Westinghouse
Electric Corporation

CAW-84-78
August 7, 1984

APPLICATION FOR WITHHOLDING PROPRIETARY
INFORMATION FROM PUBLIC DISCLOSURE

ENCLOSURE 2

14.1.2 Uncontrolled RCCA Withdrawal at Power

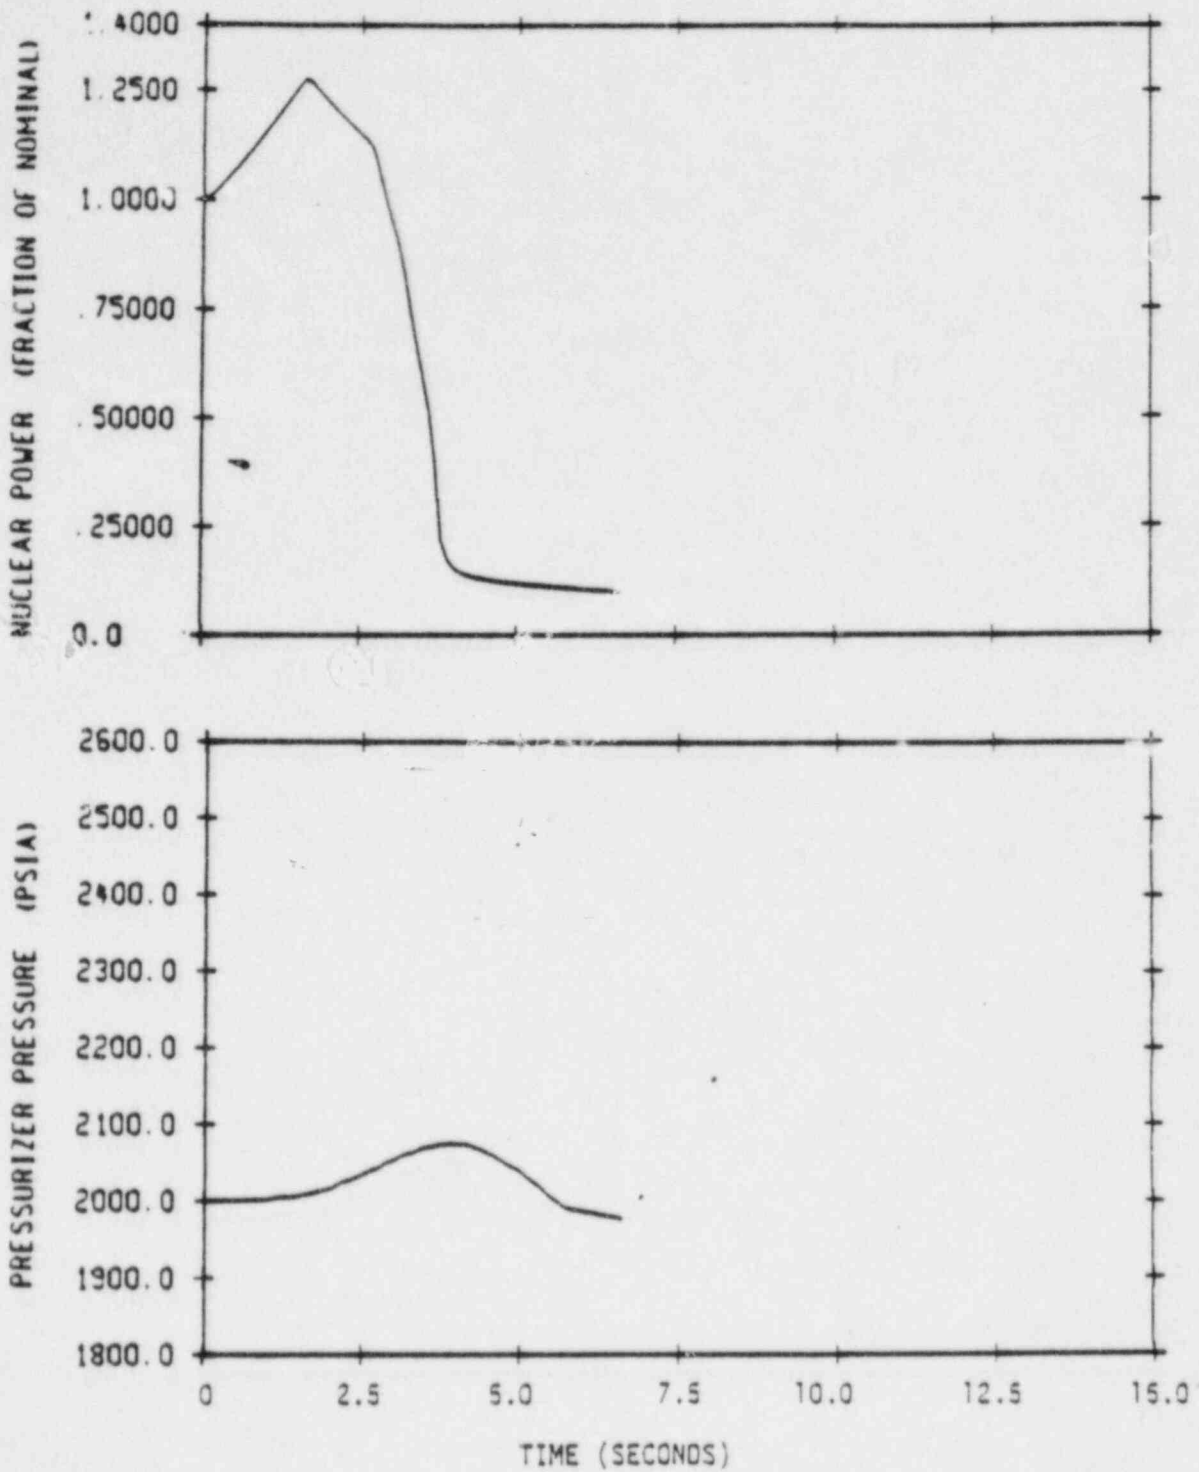
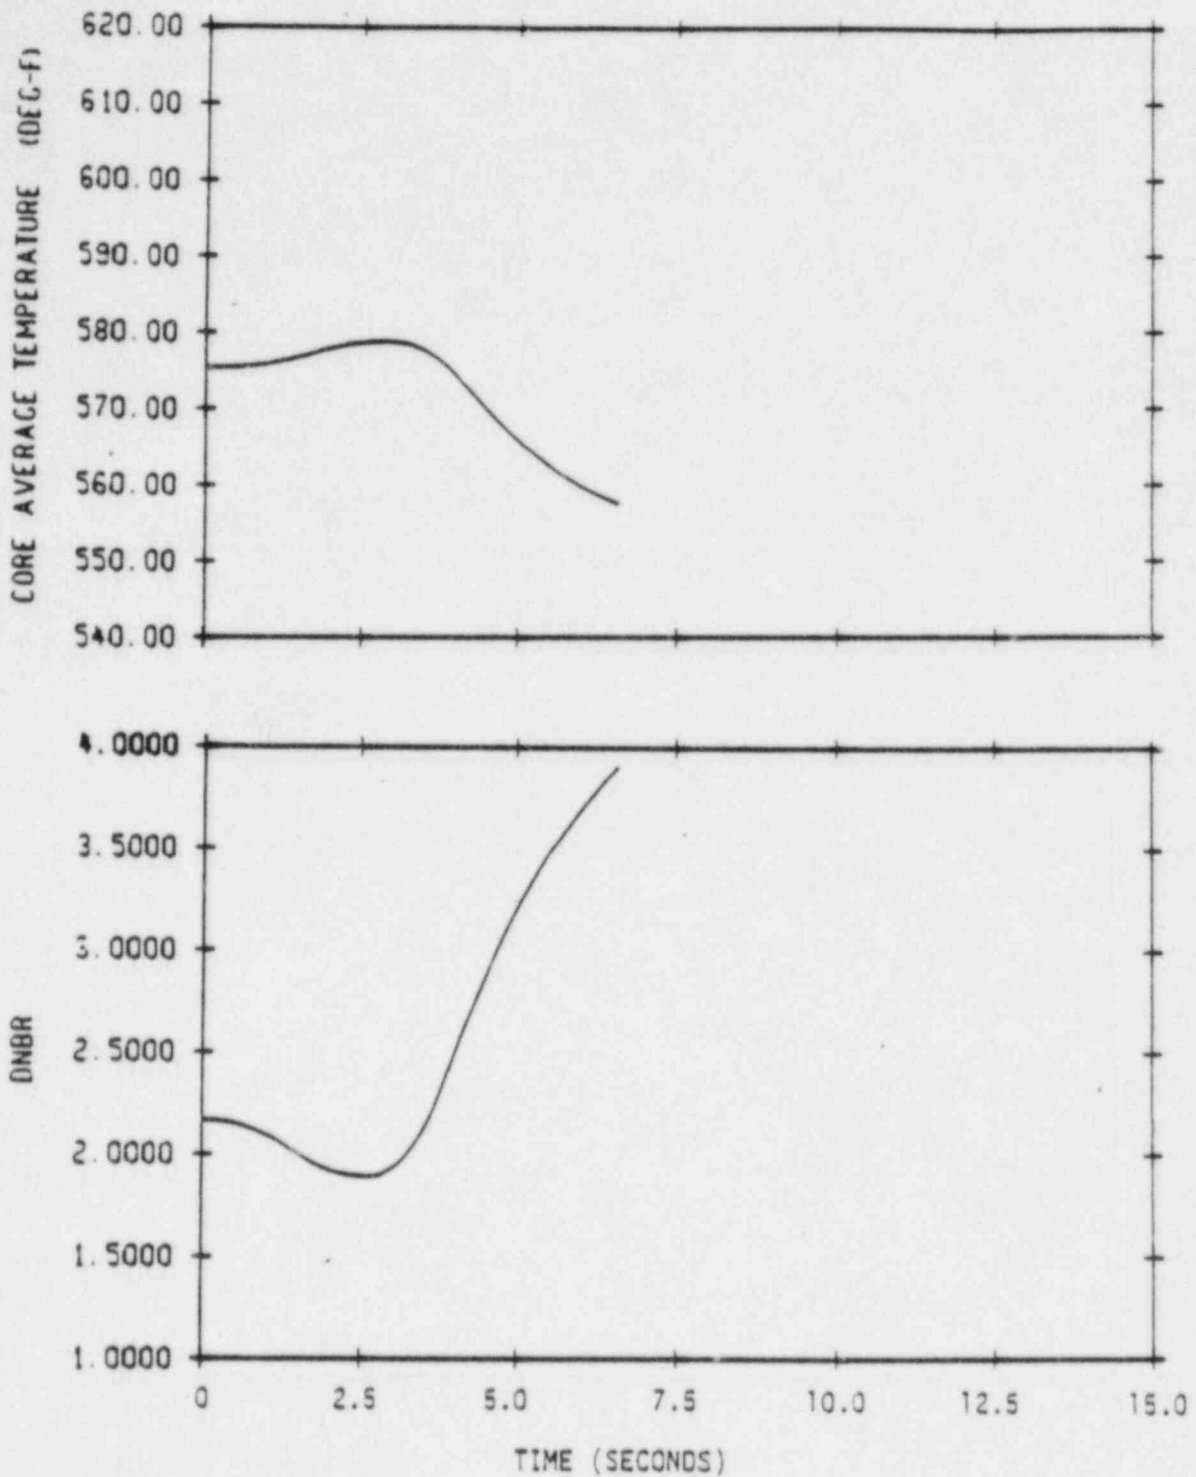
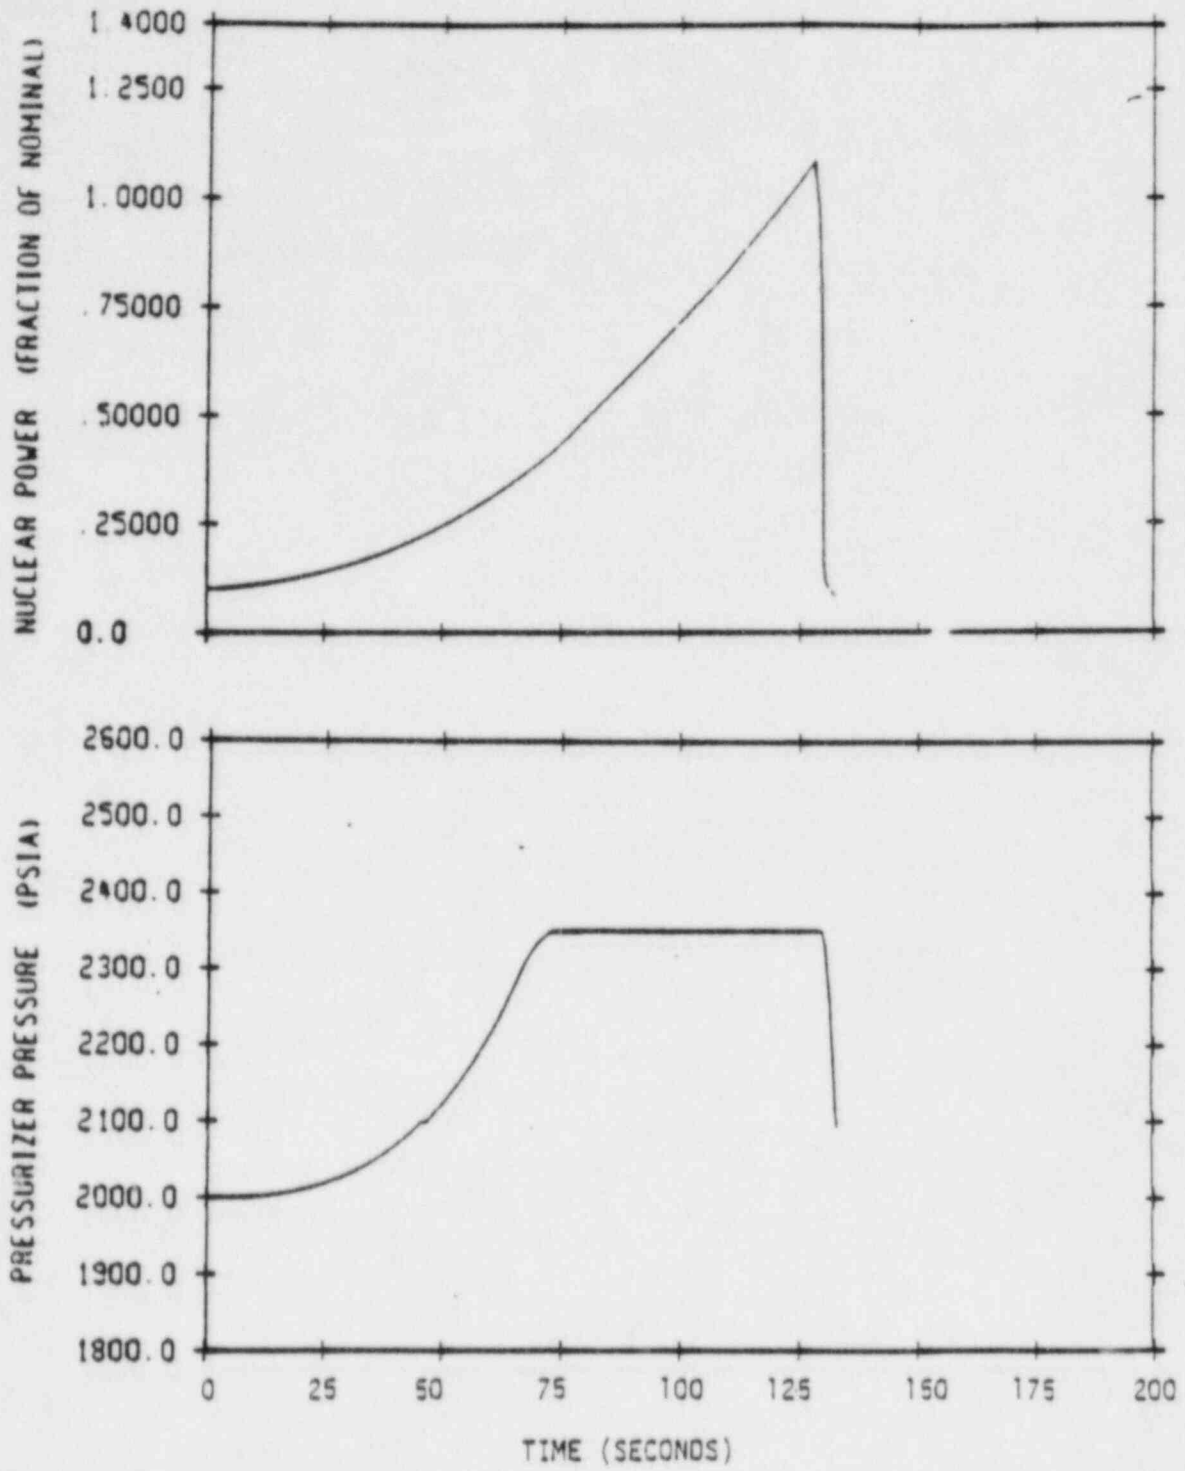
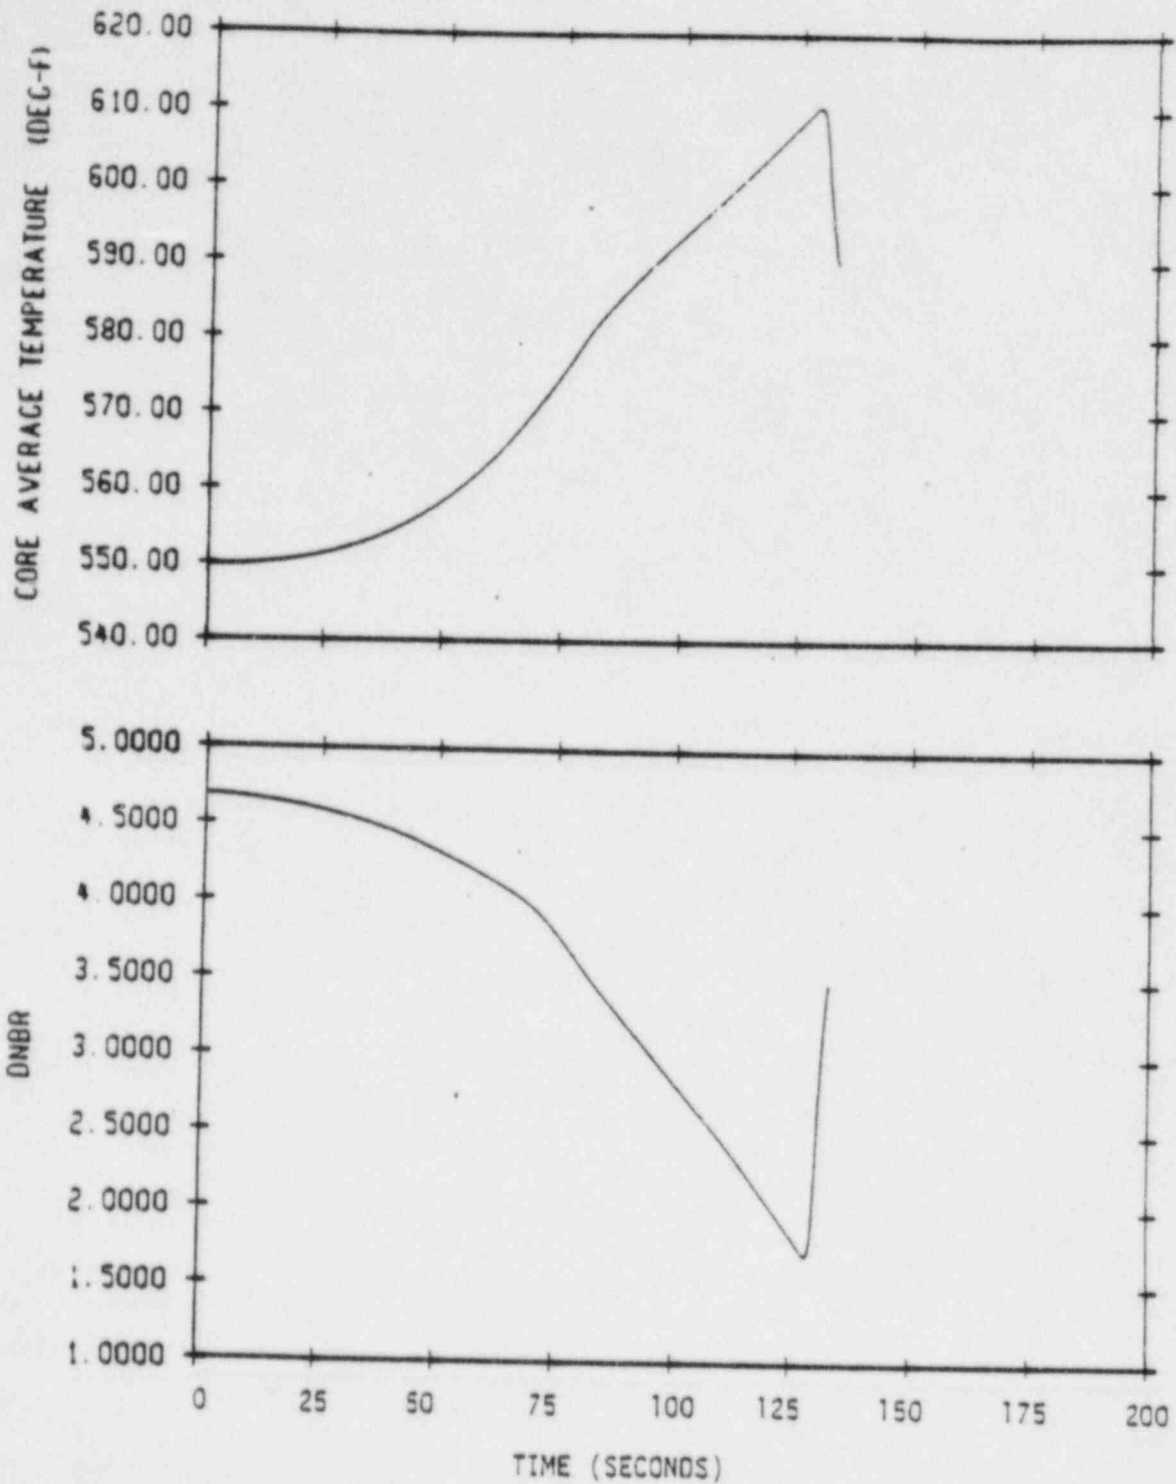
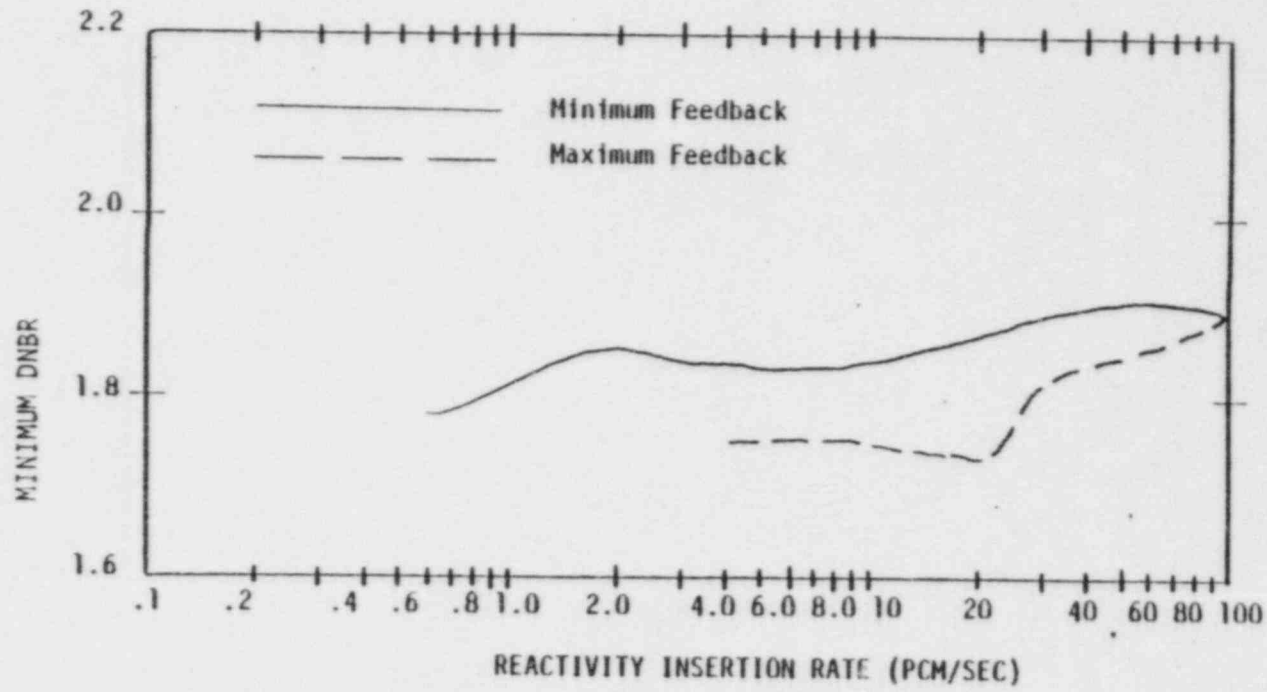
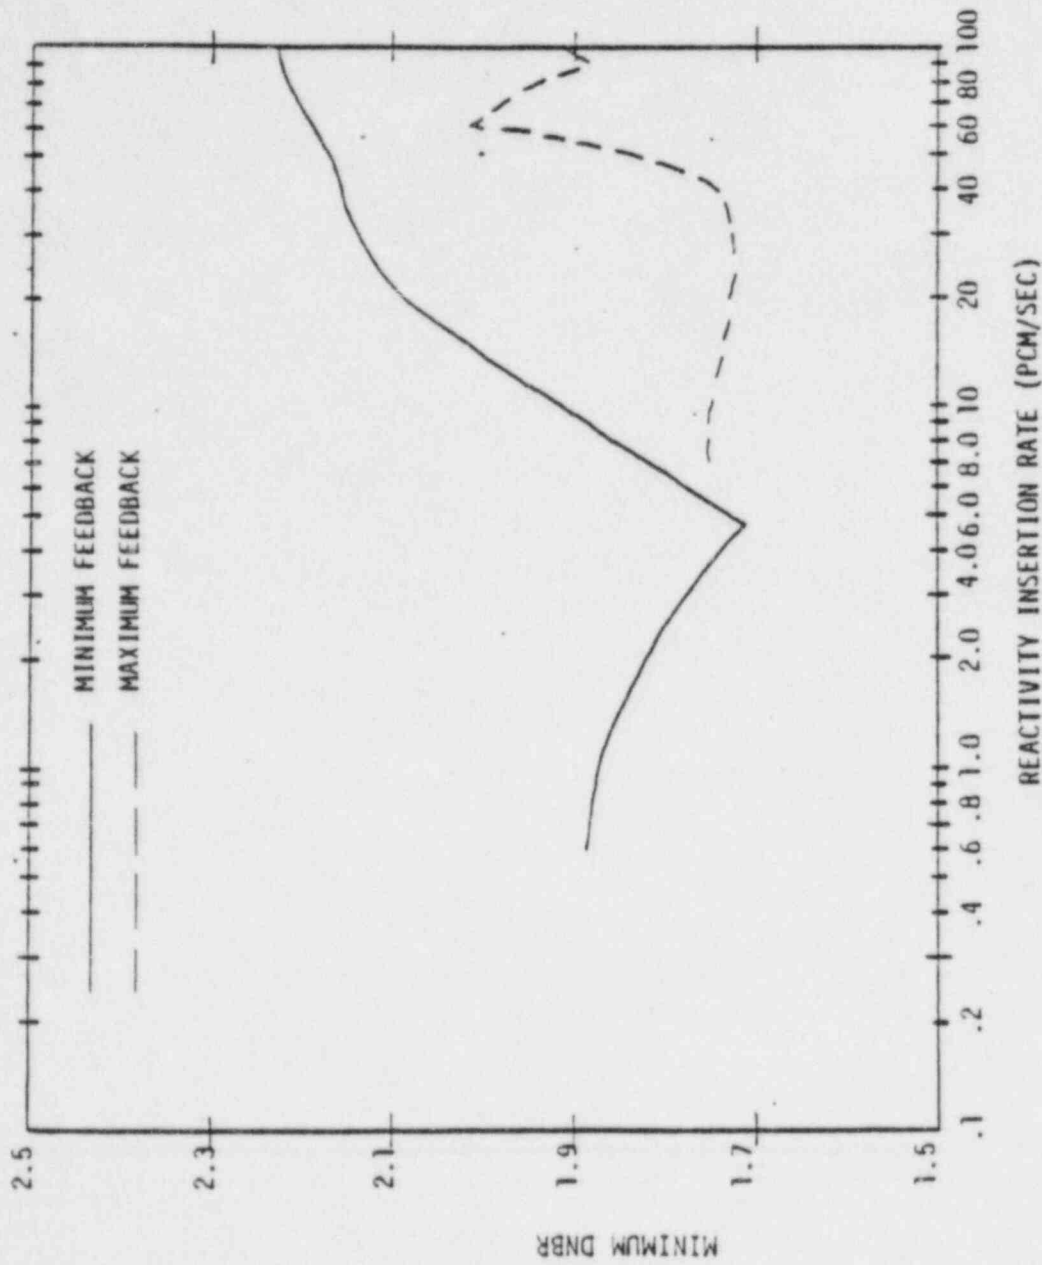
Please identify the limiting DNBR transient and provide the results of the analysis of the event, including the calculated value of minimum DNBR.

The limiting DNB transient is Uncontrolled RCCA Withdrawal at Power. Results of this postulated event, including figures of the minimum calculated values of DNBR, are attached.

Figures 14.1.2-1 and 14.1.2-2 show the response of neutron flux, pressure, average coolant temperature, and departure from nucleate boiling

The response of neutron flux, pressure, average coolant temperature, and DNBR for a slow control rod assembly withdrawal from 10% power is shown in Figures 14.1.2-3 and 14.1.2-4. Reactor trip on overtemperature ΔT occurs after a longer period, and the rise in temperature and pressure is consequently larger than for rapid rod cluster control assembly withdrawal. Again, the minimum DNBR is greater than the limit value.

Figure 14.1.2-5 shows the minimum departure from nucleate boiling ratio as a function of reactivity insertion rate from initial full-power operation for the minimum and maximum reactivity feedback cases. It can be seen that two reactor trip channels provide protection over the whole range of reactivity insertion rates. These are the high neutron flux and overtemperature ΔT trip channels. The minimum DNBR is never less than the limit value.

Figures 14.1.2-6 and 14.1.2-7 show the minimum departure from nucleate boiling ratio as a function of reactivity insertion rate for rod cluster control assembly withdrawal incidents starting at 60% and 10% power respectively. The results are similar to the 100% power case, except that as the initial power is decreased, the range over which the overtemperature ΔT trip is effective is increased. In neither case does the departure from nucleate boiling ratio fall below the DNBR limit value.
